Model: Brz-P1	Date: 23-May-16	No.: RM281002c
----------------------	-----------------	----------------

Subject: Firmware Problems/Original		Reasons for original problem have been corrected or addressed		Prepared by: T. Tachibana	
From: 2nd Tech Service Sect., MFP/Printer Tech Service Dept.					
Classification:	<input type="checkbox"/> Troubleshooting	<input type="checkbox"/> Part information	<input type="checkbox"/> Action required		
	<input type="checkbox"/> Mechanical	<input type="checkbox"/> Electrical	<input type="checkbox"/> Service manual revision		
	<input type="checkbox"/> Paper path	<input type="checkbox"/> Transmit/receive	<input type="checkbox"/> Retrofit information		
	<input type="checkbox"/> Product Safety	<input checked="" type="checkbox"/> Other (Firmware)	<input checked="" type="checkbox"/> Tier 2

Model: Brz-P1		Date: 31-Aug-16	No.: RM281017
Subject: Parts Catalog Correction on Operation Panel		Prepared by: T. Tachibana	
From: 2nd Tech Service Sect., MFP/P Tech Service Dept.			
Classification:	<input type="checkbox"/> Troubleshooting <input type="checkbox"/> Mechanical <input type="checkbox"/> Paper path <input type="checkbox"/> Product Safety	<input checked="" t

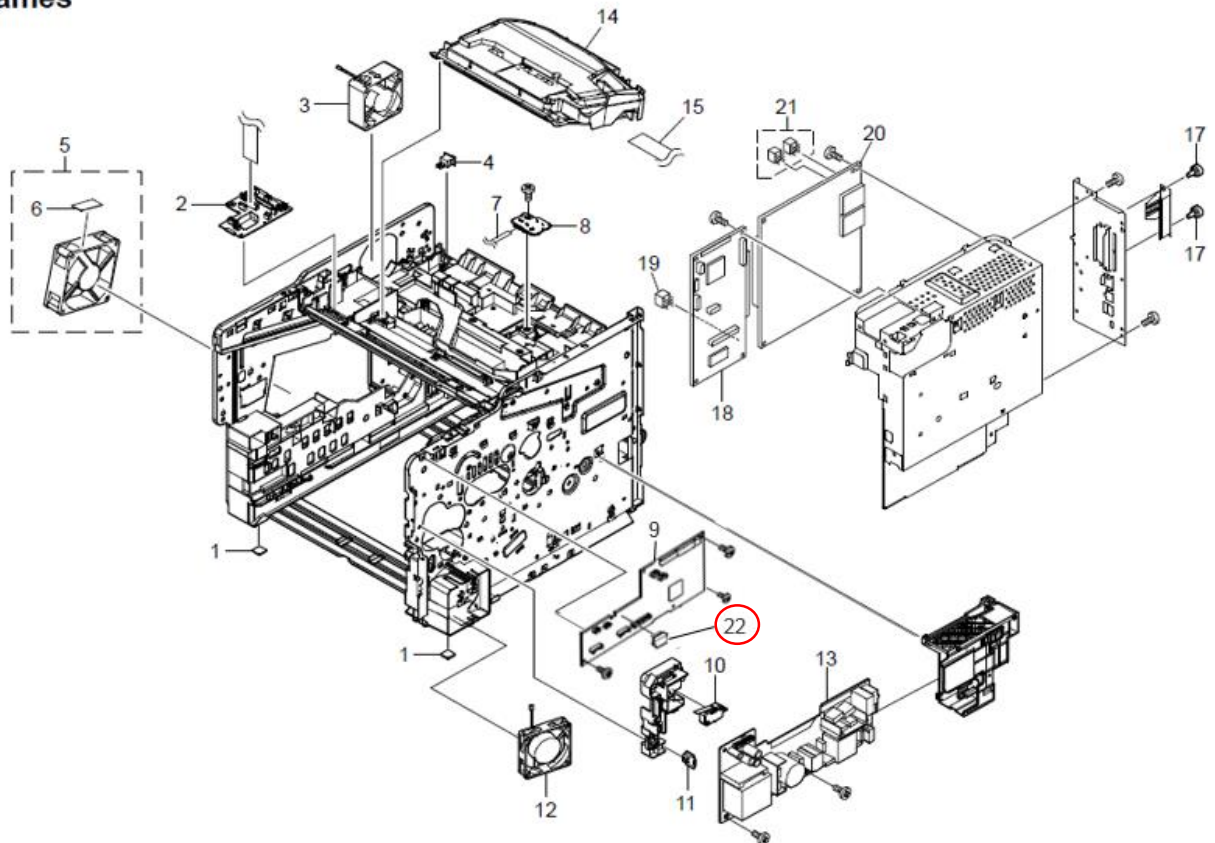
Change/Reason: The following part numbers were corrected.

Correct part number	Description	Q'ty	Int	Page	Index	Note
M2811423	SHIELD LCD	1		4	21	
M2811492	HARNESS:FFC:SENSOR	1		4	22	
M1291470	PCB:4.3-P:SENSOR:ASS'Y	1		4	23

4. Paper Feed Section

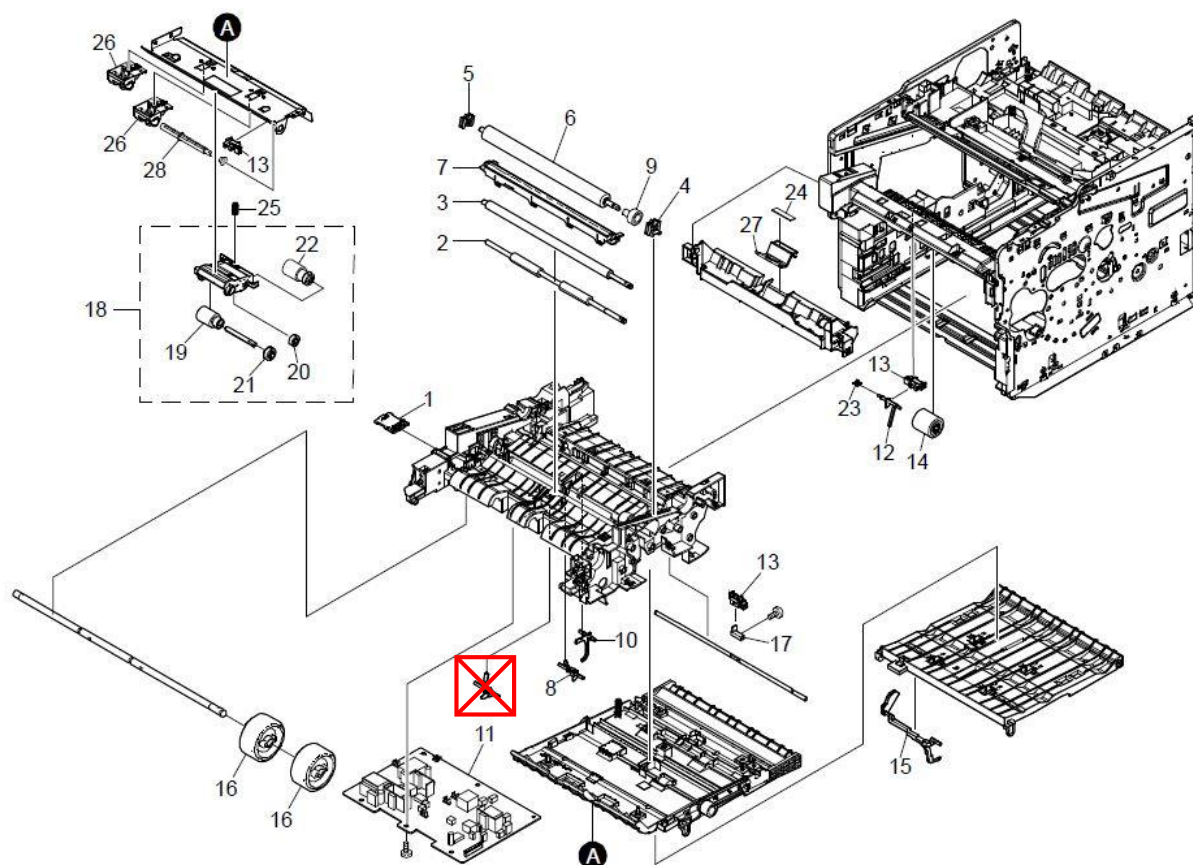
Change: The illustration of the actuator outlined in red was deleted.

Reason: Brz-P1 does not have this actuator.

1.Covers

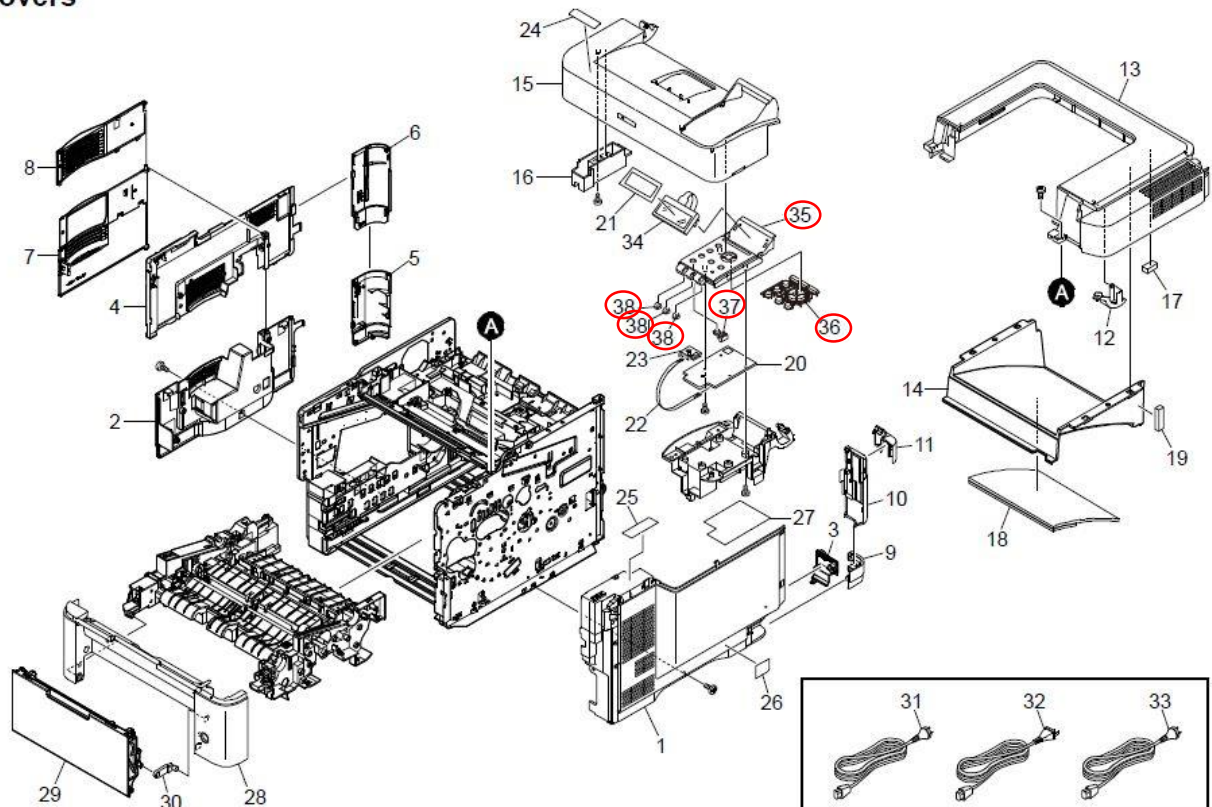
Change: These parts are newly added.

Part number	Description	Q'ty	Int	Page	Index	Note
M2811420	LID OPERATION	1		4	35	
M2811424	KEY A	1		4	36	
M2811425	KEY PAUSE	1		4	37	
M2811427	LENS LED	3		4	38

2. Frames

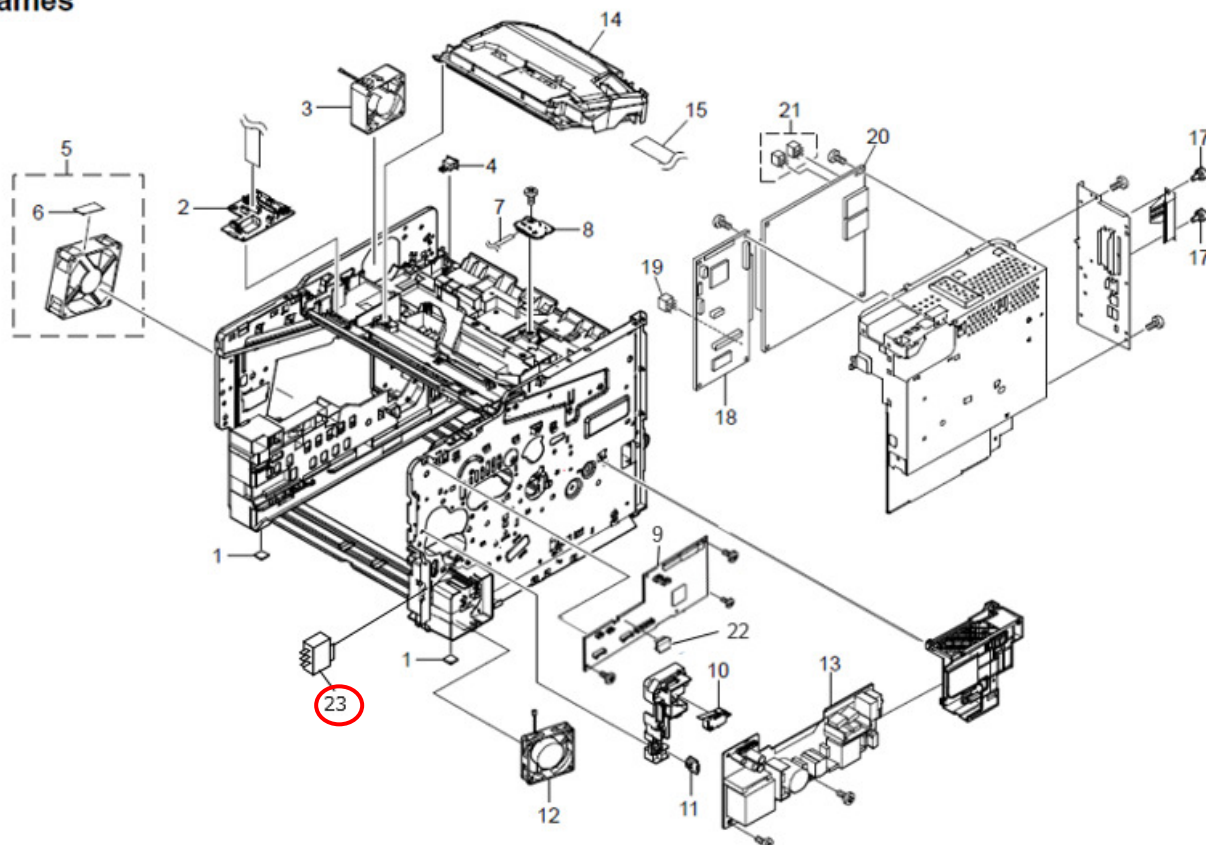
Change: These parts are newly added.

Part number	Description	Q'ty	Int	Page	Index	Note
M2812860	SW.PUSH	1		6	23

9. Drive Section

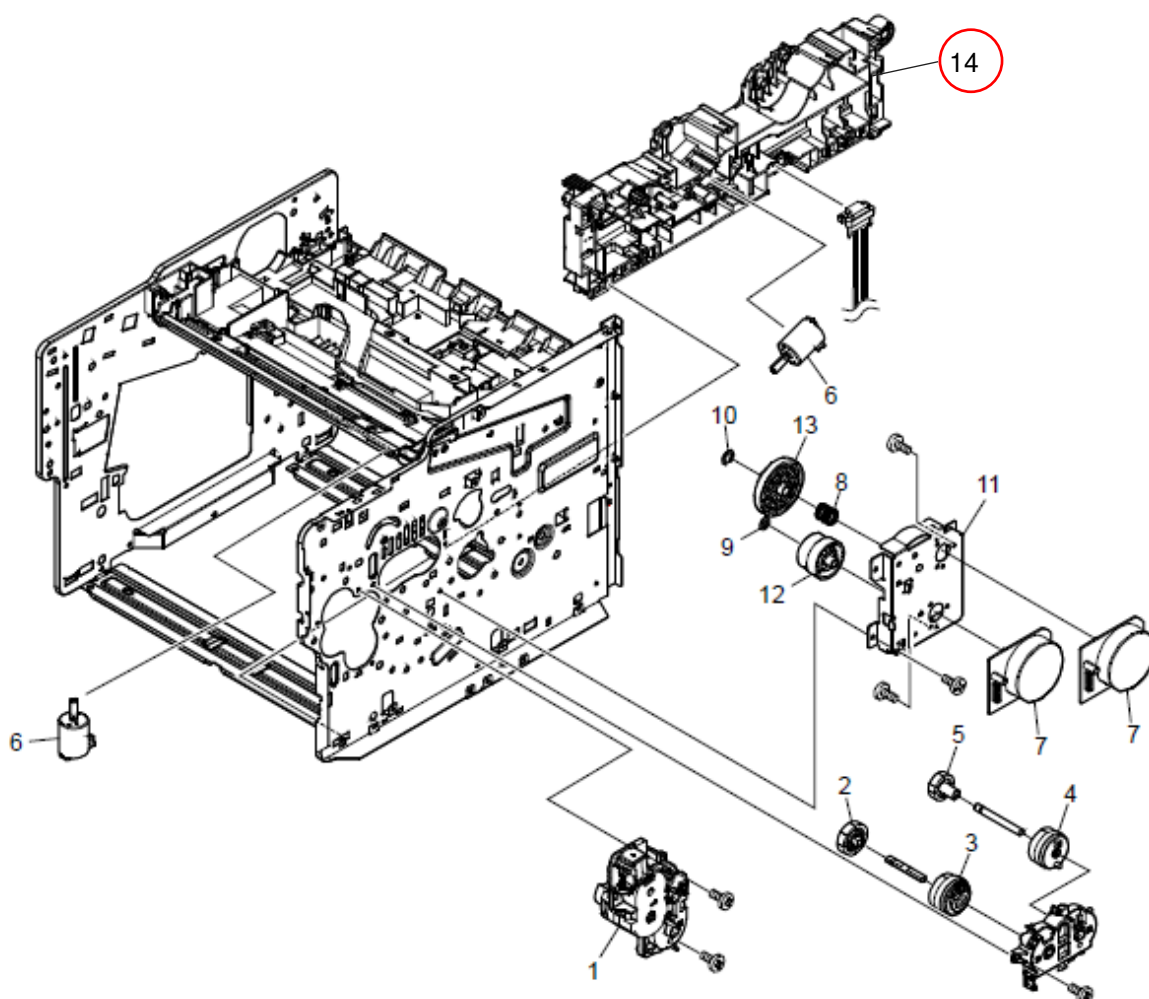
Change: The guide cassette has been registered as a service part.

Old part number	New part number	Description	Q'ty	Int	Page	Index	Note
	M2811182	GUIDE CASSETTE R	0-1	-	20	14

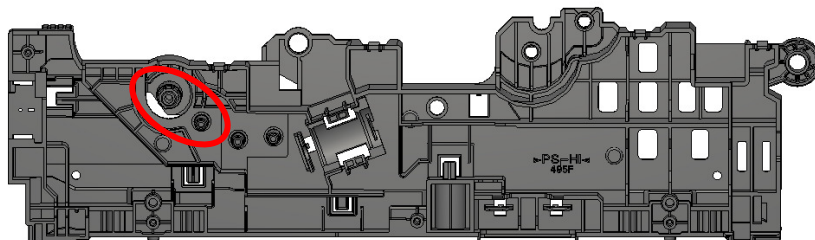
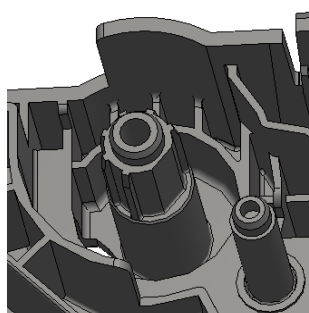
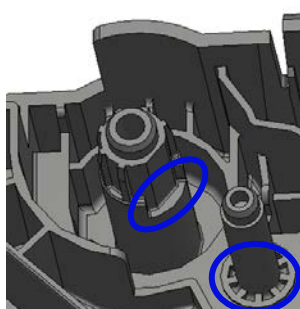
The shafts circled in red have been modified because they may turn white or break. If the shafts are broken, SC501-01(Paper Feed Tray Lift Motor Error (Tray 1)) appears.

New: The shape of the parts circled in blue have been modified.

9. Drive Section

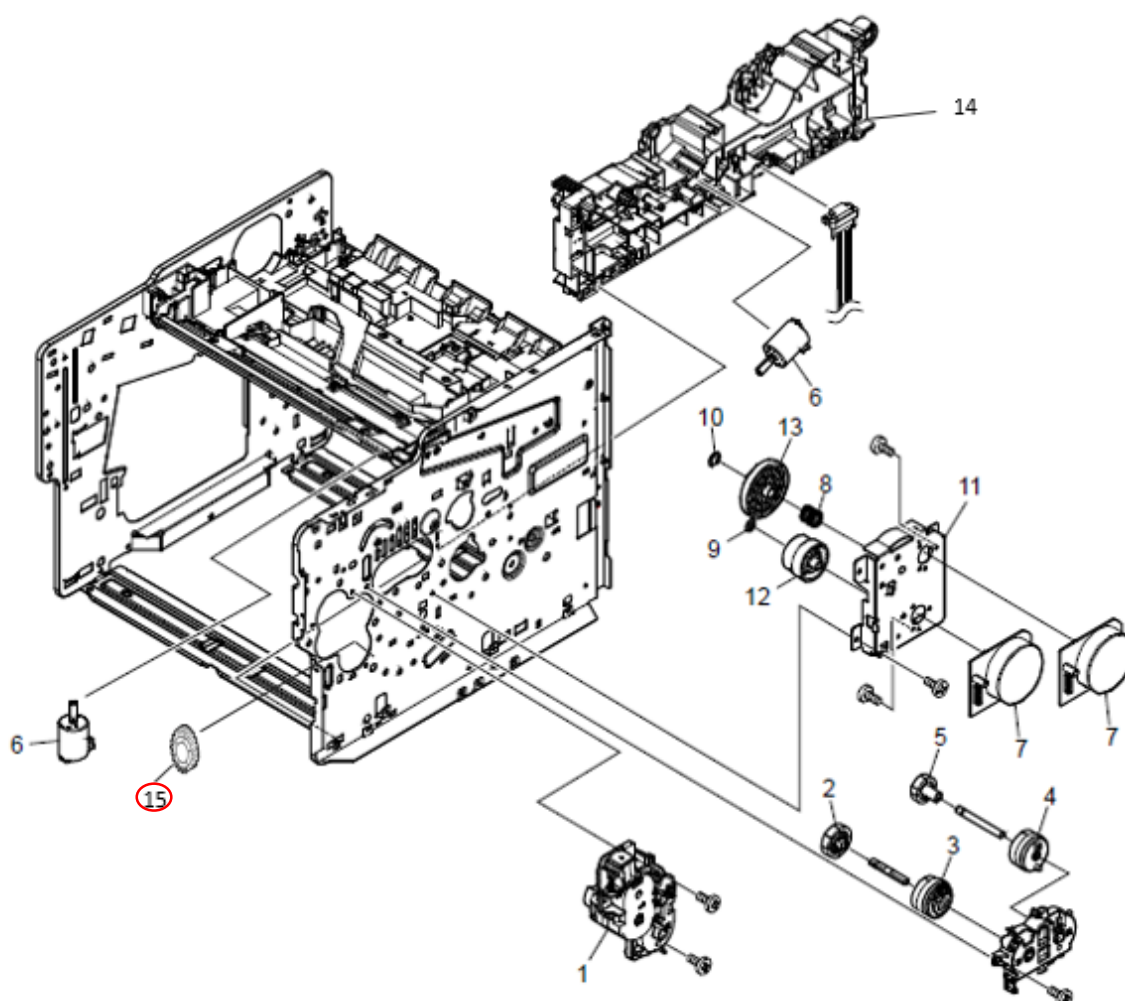
Change: This parts is newly added.

Old part number	New part number	Description	Q'ty	Int	Page	Index	Note
	M2811130	GEAR Z35S-Z13S B	0-1	-	20	15

8. Exit Section

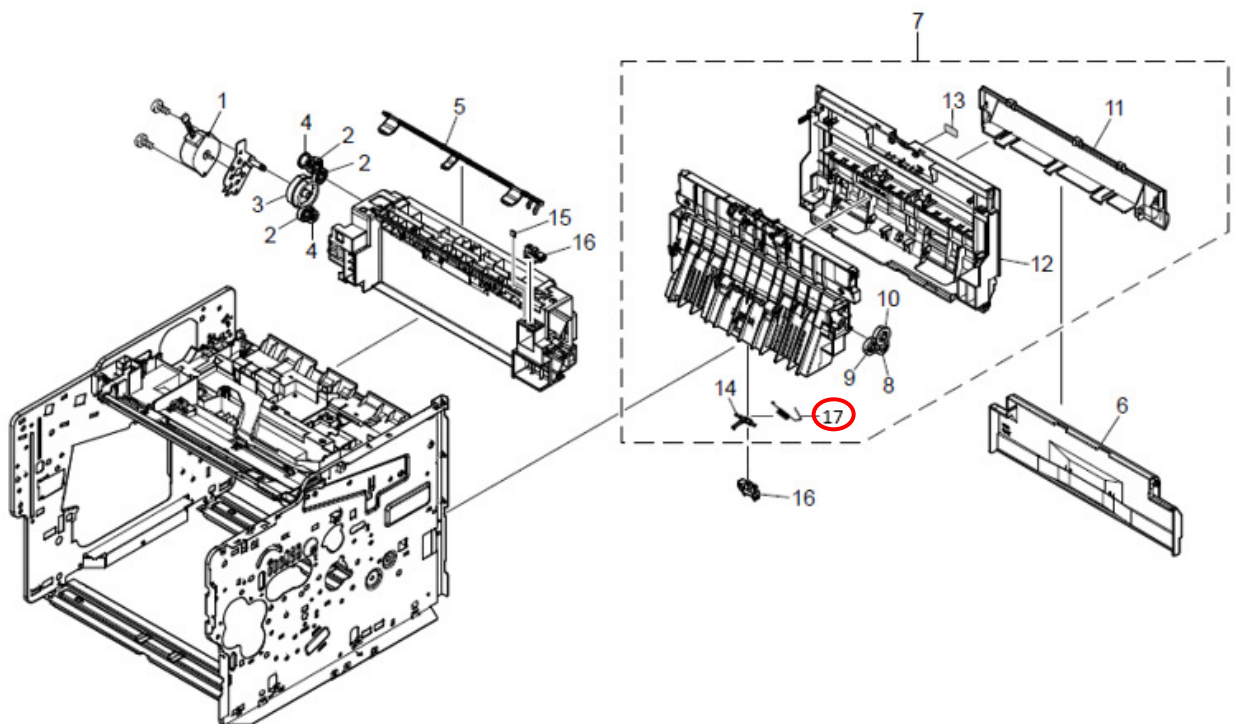
Change: A new part has been added.

Reason: To make it possible to replace the spring individually when a duplex jam occurs (Jam code: 86).

Part number	Description	Q'ty	Int	Page	Index	Note
M2814458	SPRING ACTUATOR DU	1		18	17

9. Drive Section

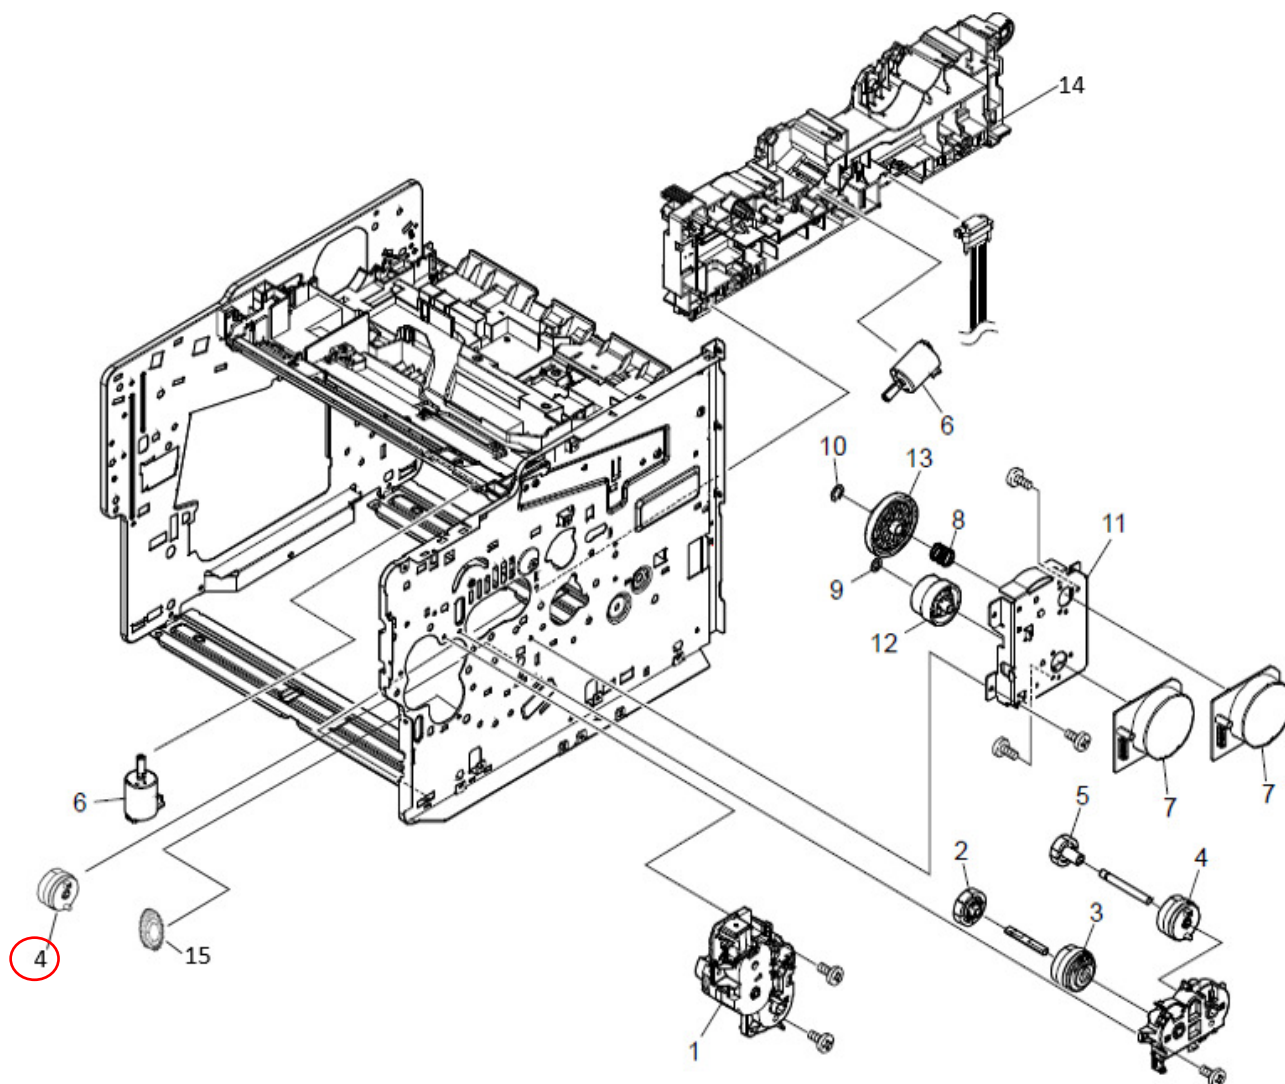
Change: The duplex clutch is newly added.

Part number	Description	Q'ty	Int	Page	Index	Note
M2811127	PARTS CLUTCH 20-2W Z35R	1-2	-	20	4

8. Exit Section

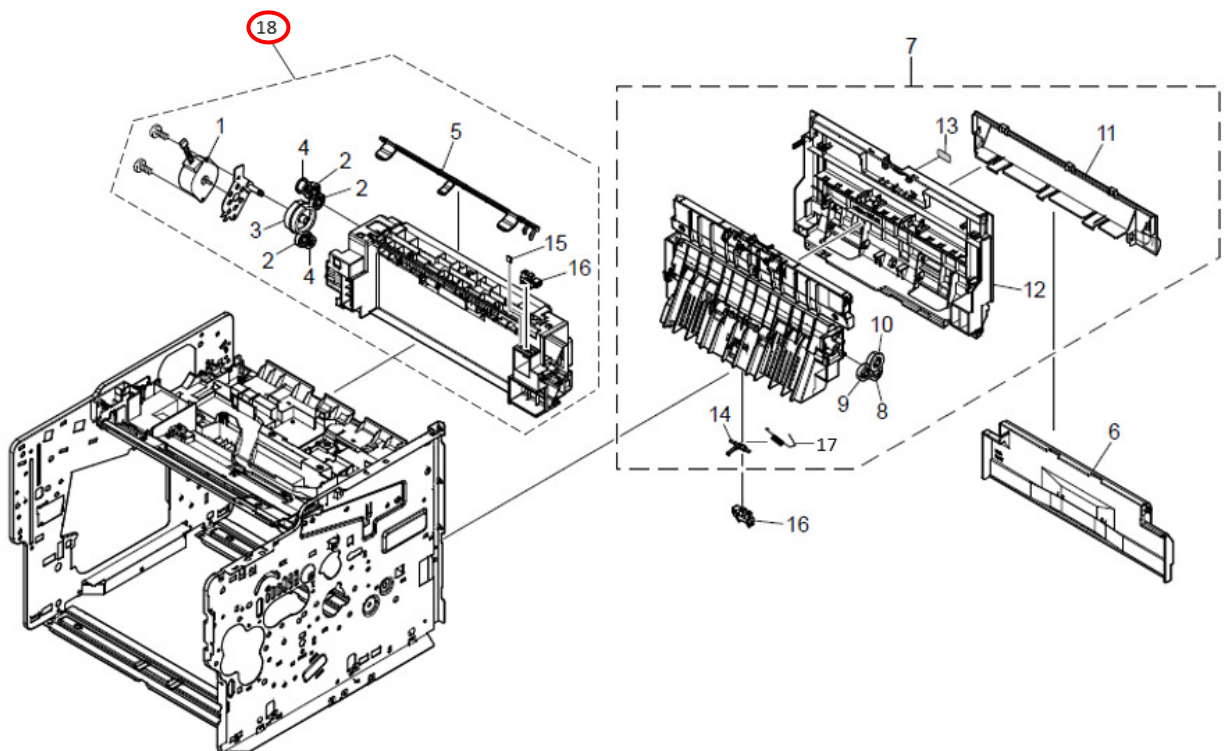
Change: A new part has been added.

Part number	Description	Q'ty	Int	Page	Index	Note
M2824457	PARTS EXIT UNIT SP	1		18	18
